National Marine Electronics Association

Technical Corrigendum   TC# 0183 20150316

NMEA 0183 Version 4.10
CBR Sentence
COP Sentence
MEB Sentence

CBR – Configure Broadcast Rates for AIS AtoN Station Message Command.

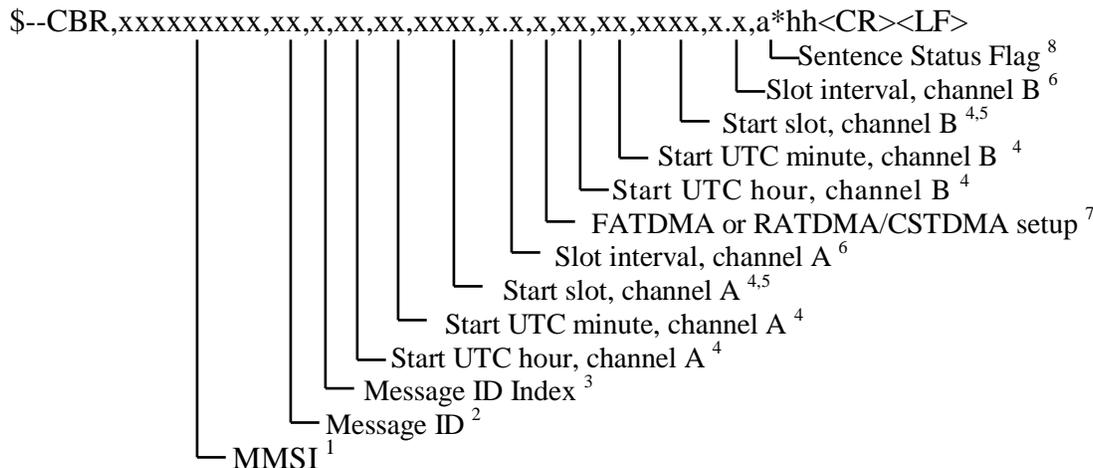
CBR Sentence
Notes 5, 6 and 7 have been expanded.

5) Starting slot valid range is -1 to 2249.
   - A value of –1 clears the schedule and discontinues the broadcasts for the indicated channel(s).
     For FATDMA, a null field indicates no change to the current start slot setting when set to the AtoN Station.
     For RATDMA, start slot defines the first slot of the RATDMA selection interval.
     For RATDMA, a null field indicates that the selection interval randomly selected within the frame.
   - ~~A null field indicates no change to the current start slot setting when sent to the AtoN Station.~~

The query response for the start slot selection interval when in RATDMA mode does not distinguish between a previous commanded value or a random chosen value.
- **The current start slot of the selection interval (the value as specified by a previous CBR command sentence).**
- **The current start slot of the selection interval (the value chosen randomly by the AIS device as specified by a previous CBR command sentence).**

6) Message transmission slot interval, valid range is -1 to 3 240 000 slots (24*60*2250 = 3 240 000 is once per day). **When configuring a AtoN Station with an RATDMA/CSTDMA schedule the valid range is: 0 to (24*60*60) slots.** A null field indicates no change to the current slot interval setting when sent to the AtoN Station.   In response to a query this field cannot be null, -1 indicates that the slot interval is not set.

7) Used to select whether the CBR is configuring a FATDMA schedule or RATDMA/CSTDMA schedule (0 indicates FATDMA, 1 indicates RATDMA, and 2 indicates CSTDMA). ~~For RATDMA/CSTDMA mode, scheduled transmissions are between the slot interval and the slot interval plus 150 slots~~. **For RATDMA/CSTDMA modes, the Slot Interval is the time between the start slots of the Selection Intervals.**

COP – Configure the Operational Period, Command

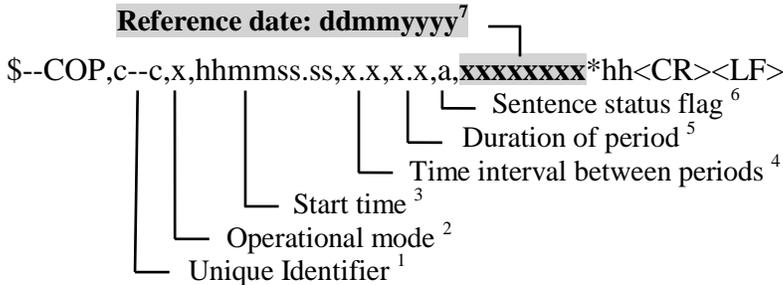
COP Sentence
This sentence has been extended with the "Reference date" data field.
Note 7 has been added for this new field.

Name of new field is:

Reference date: ddmmyyyy[7]

$--COP,c--c,x,hhmmss.ss,x.x,x.x,a,**xxxxxxxx***hh<CR><LF>

7) **The Reference date specifies the date for Time intervals greater than 24 hours when choosing a start day of schedule that is different than the current day.**

MEB – Message Input for Broadcast, Command

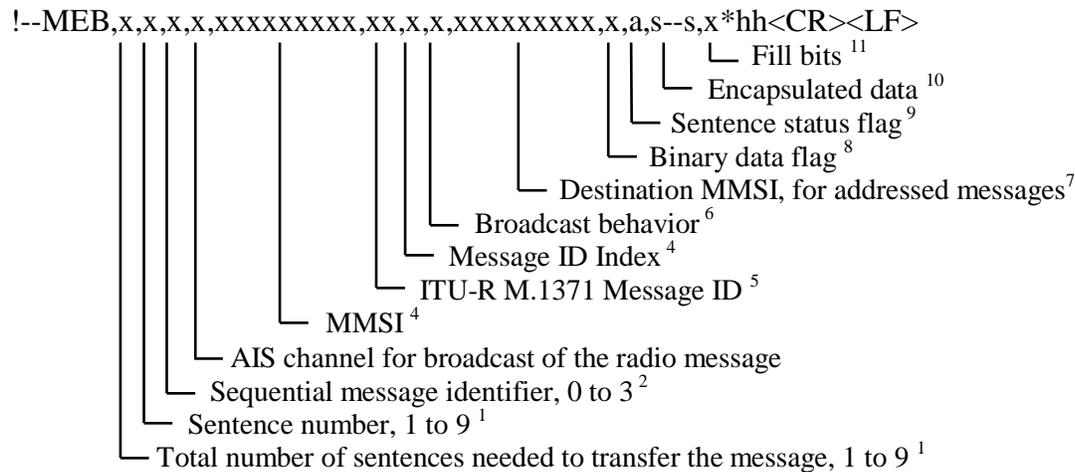
MEB Sentence
Note 6 has been expanded.

0 = For an AtoN device, the message is stored **in volatile memory** for autonomous continuous transmission as defined by a CBR sentence. The message is identified by the combination of MMSI, Message ID, and Message ID Index.

- **If a MEB is received for a given MMSI, Message ID, and Message ID Index and the MMSI, Message ID, and Message ID Index, already has a broadcast schedule then that schedule is used to send the new message**.
- **If a MEB is received for a given MMSI, Message ID, and Message ID Index and the MMSI, Message ID, and Message ID Index, does not have a broadcast schedule, then the message is transmitted using the next available slot using the following priority scheme.**
    - **Use CBR definition, Message ID = 0, Message ID Index = 0 (if available)**
    - **Use RATDMA if supported by the AtoN unit**
